VILLAGE PLAN COMMISSION AGENDA

ITEM DESCRIPTION: Site & Architectural Review Amendment – Rebman Plumbing located at 700 W Kimberly Avenue

ITEM DESCRIPTION: Preliminary Plat Review – The Blues (Replat of the Condominium Plat – The Blues at the Trails)

REVISIONS
DRAWN BY: RVL
DATE DRAWN: APRIL 3, 2025
PROJECT MANAGER: JASON BUKOSKI
JOB NUMBER: 25A09
SHEET 2 OF 7

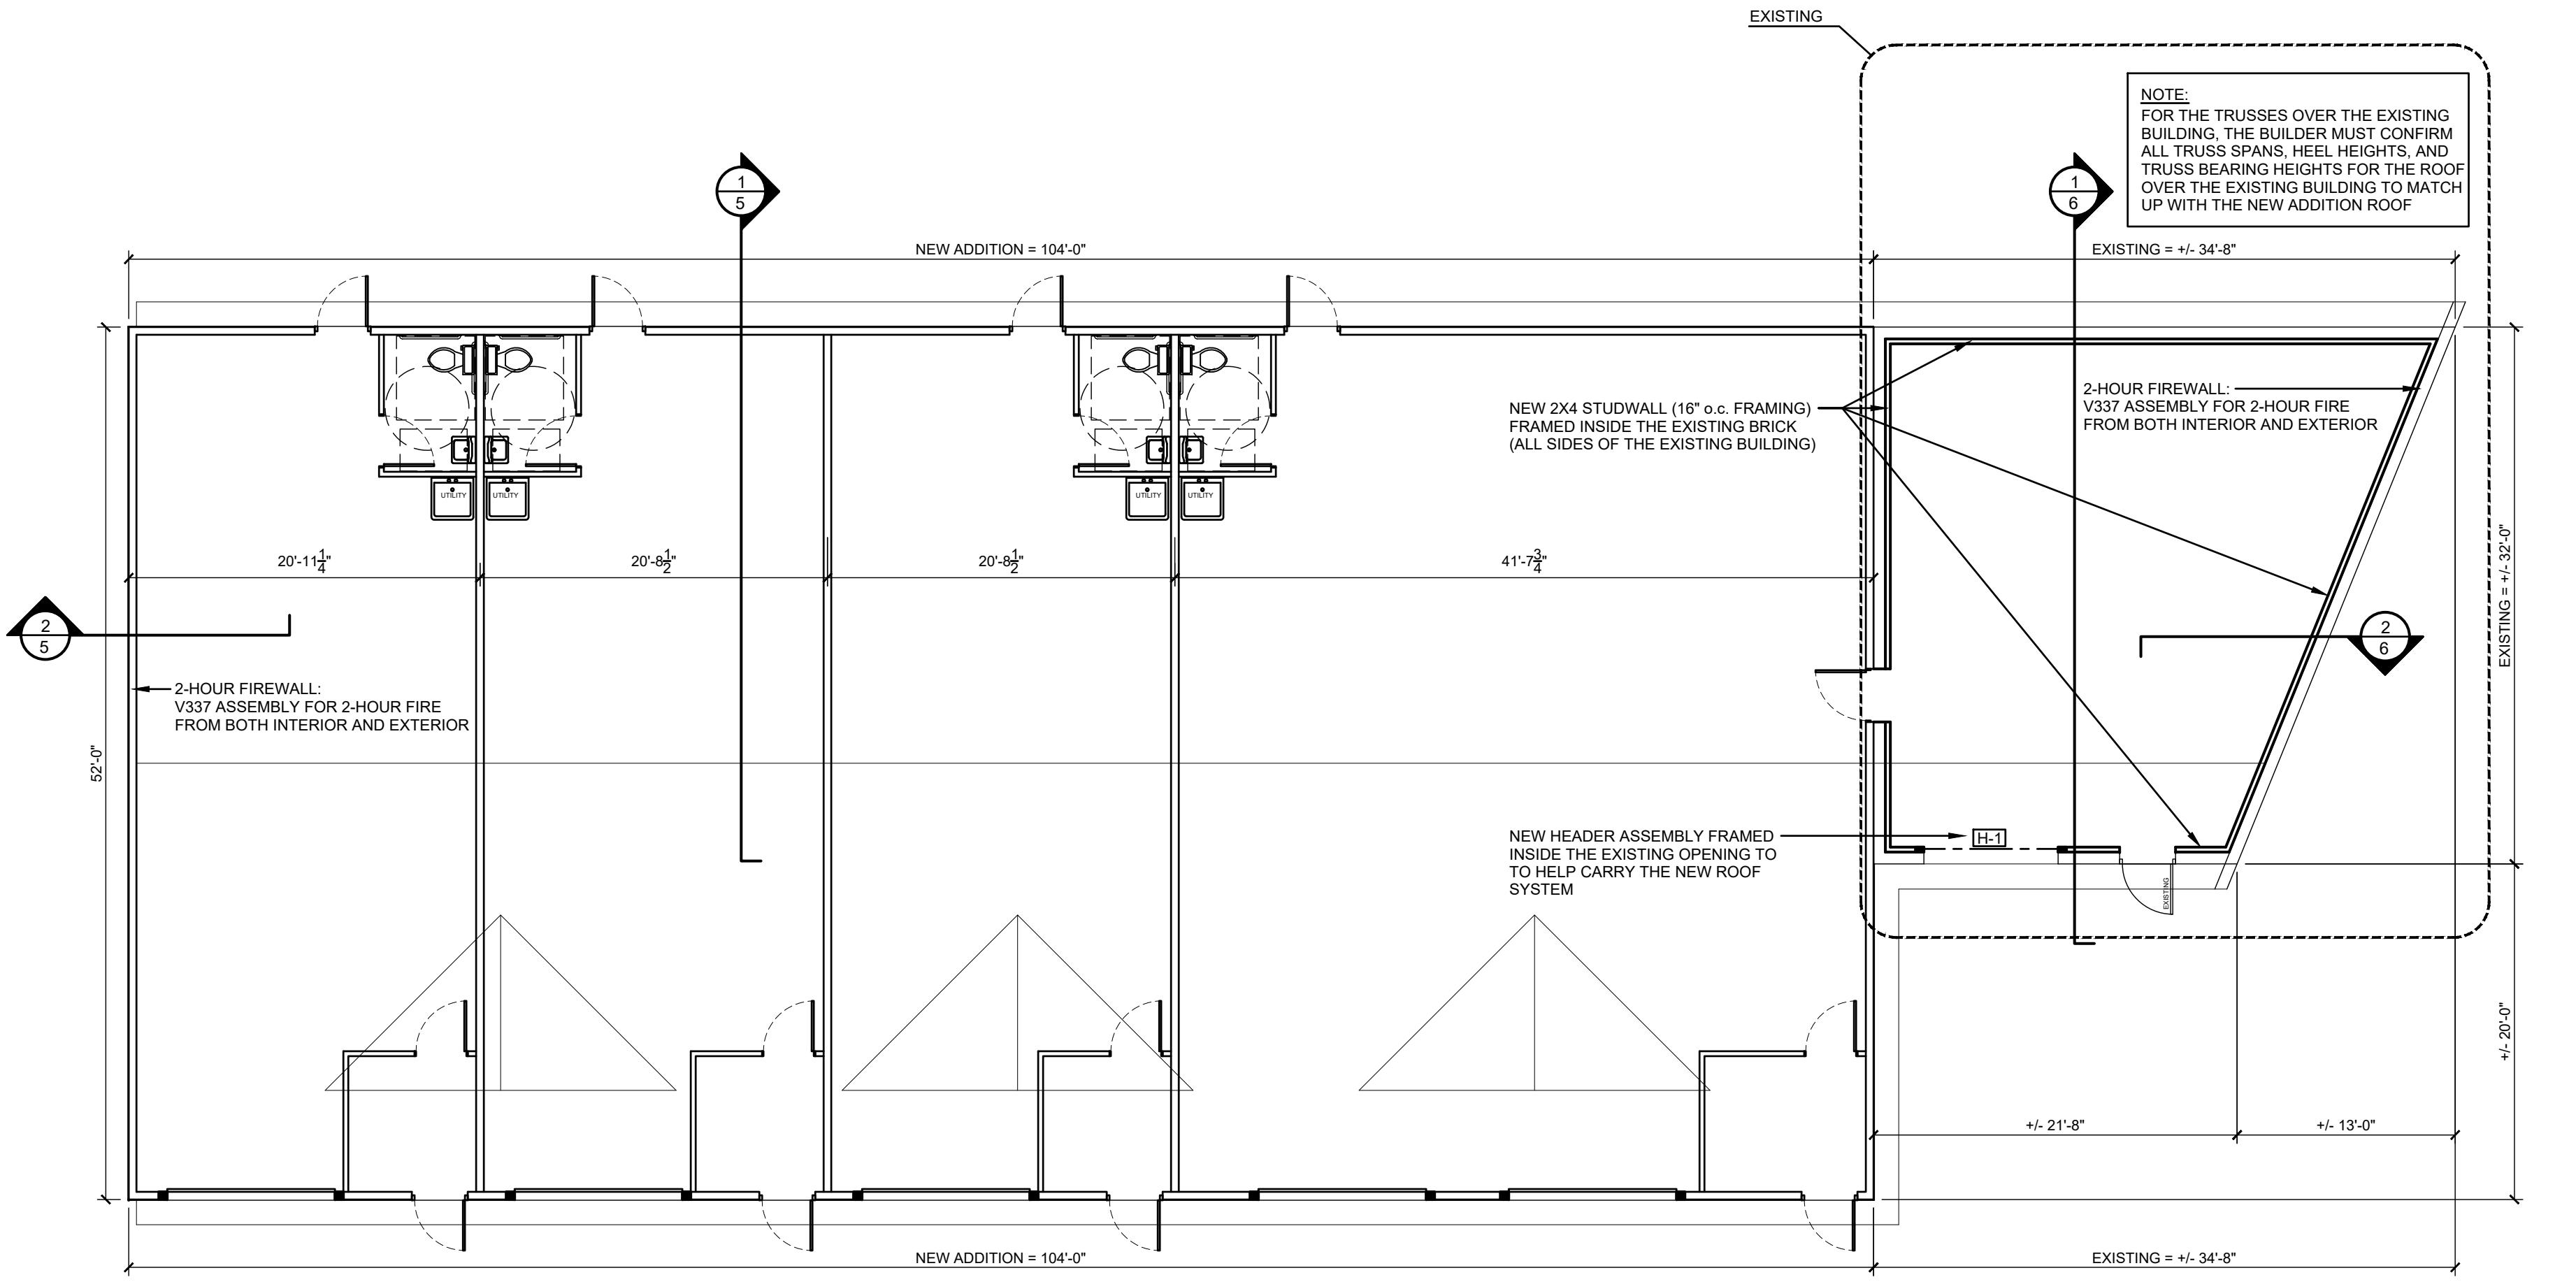
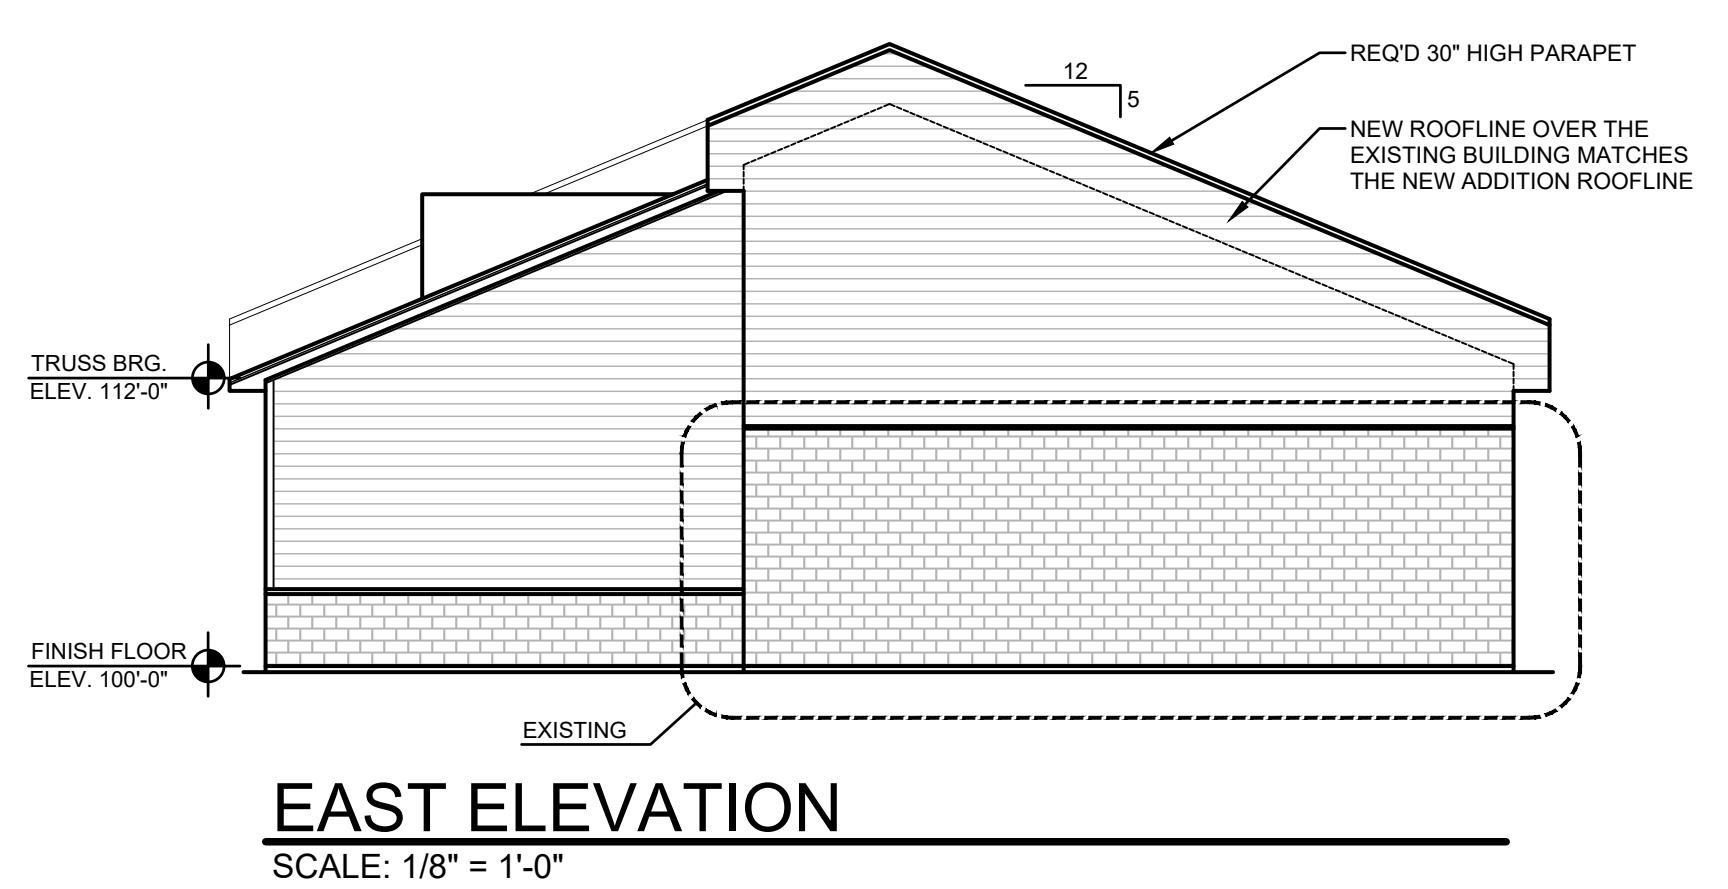
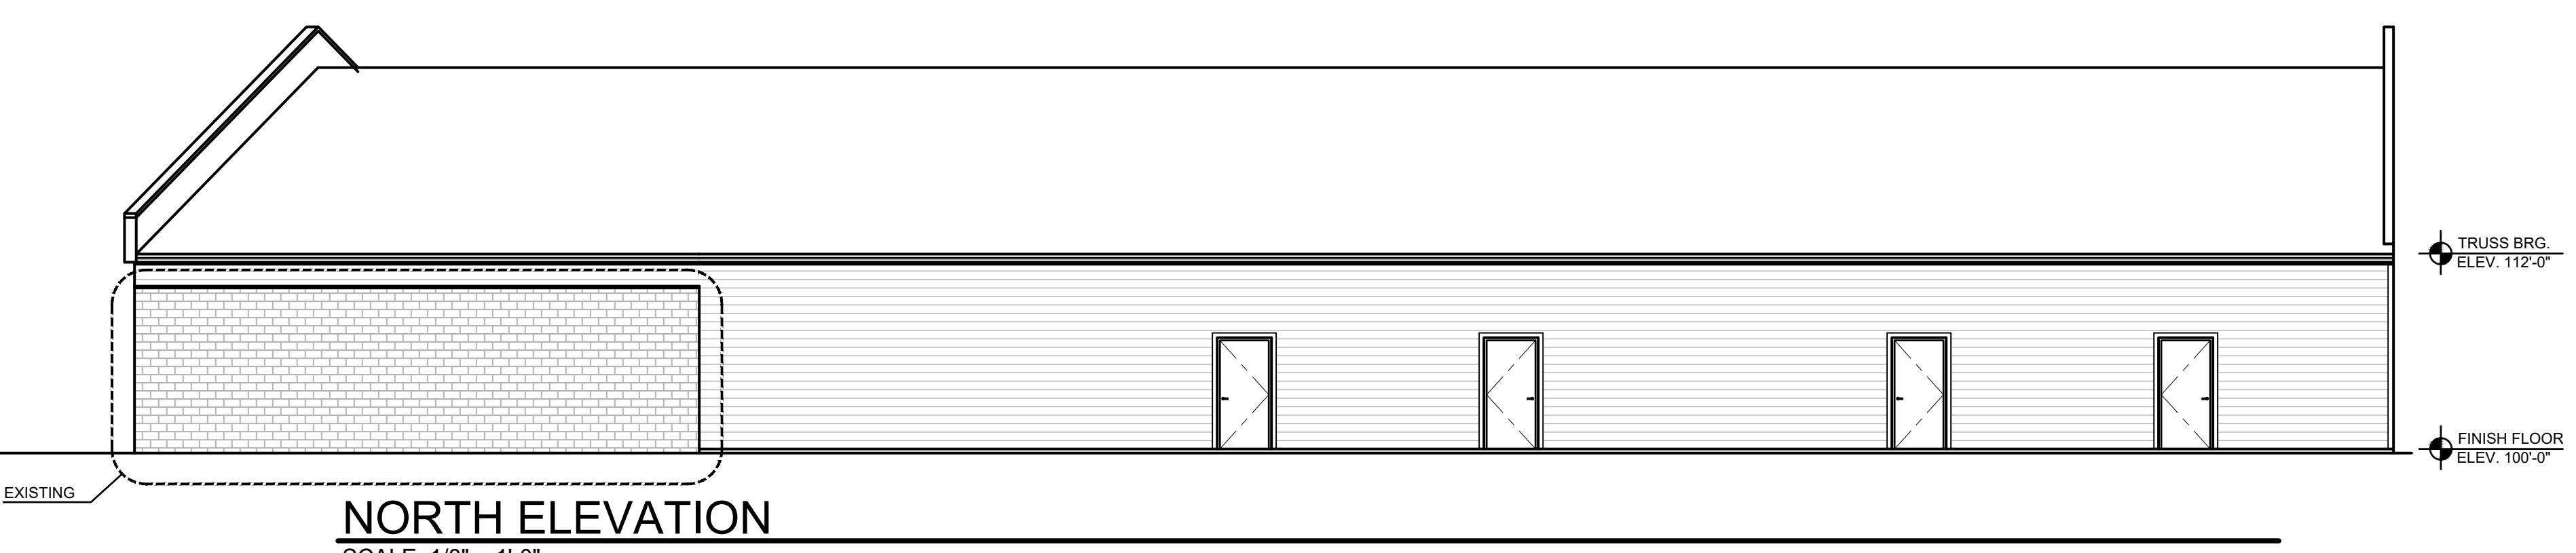
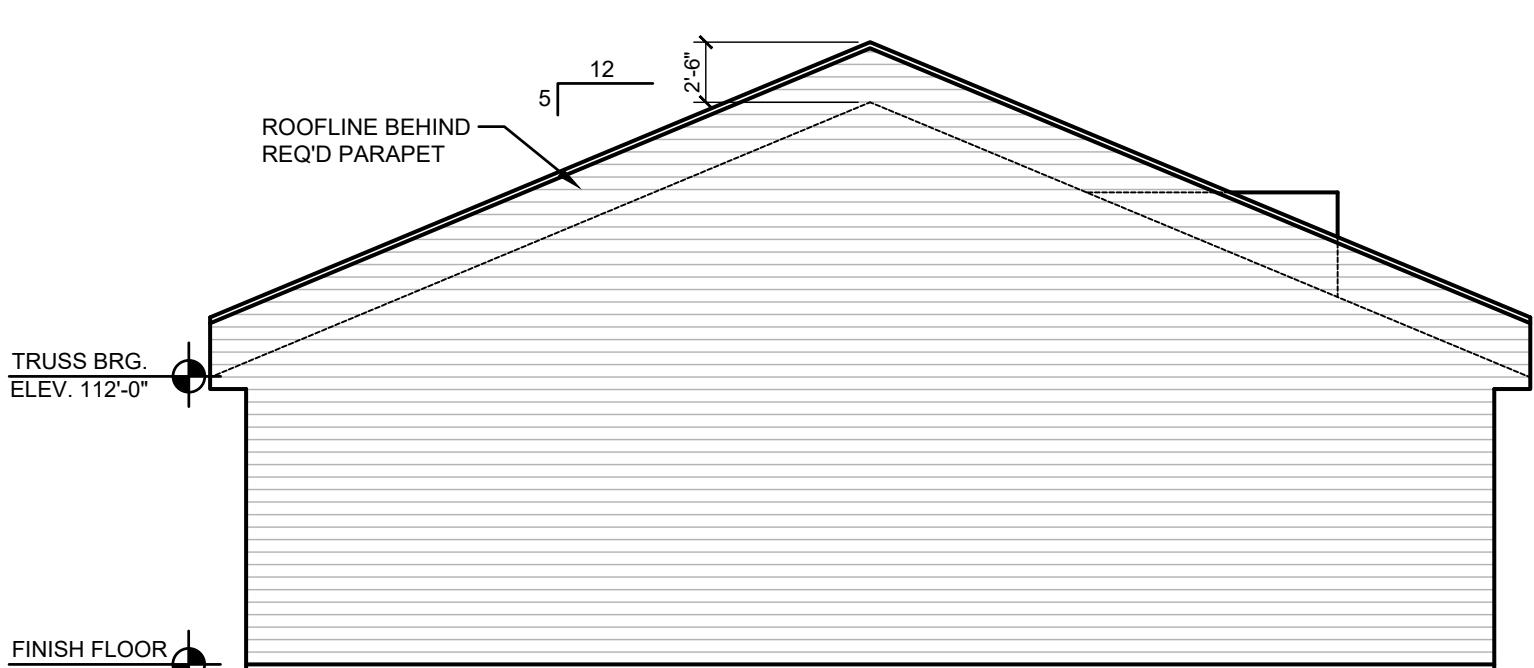
Since that time, the plans did go through commercial plan review and construction has commenced. It was identified as the building took shape that the building currently under construction does not match the approved site and architectural drawings submitted in December of 2024. The Property Owner noted certain changes were made ahead of the commercial plan review which is reviewed by a third party. Those plans were further refined with neither being reviewed nor approved by zoning. Changes are summarized below.

- Parapet walls versus the gabled overhangs
- Pitched roof structure over the existing building
- Removed overhangs above front entrance doors

- Brick on the existing building was primarily covered with vinyl siding with the exception of brick wainscoting on the south facade
- Brick wainscoting on east side of new building back to old building was removed
- The window/door on the existing building was removed
- The overhangs above the front entrance doors will be added contrary to the plan per the Property Owner*

- The parapet wall and the removal of the door on the existing building were due to the fire separation requirements.
- The structure installed over the existing building was due to the concern of snow load and tying that into the new building to avoid future water and drainage issues.

BRICK REMOVED ON
EXISTING BLD
RETURN

RECOMMENDED ACTION: At this stage in the project, Staff would recommend approval of the building as currently being constructed with no changes to the approved grading and drainage, the overall site plan, the landscaping, or any other conditions as originally approved and with added condition that the overhangs above the front entrances would be added.

Should the Plan Commission desire, Staff believes there could be consideration to require added brick wainscotting on the east and west façade as well as the wall returned back to the existing building. All other approvals and conditions should remain.
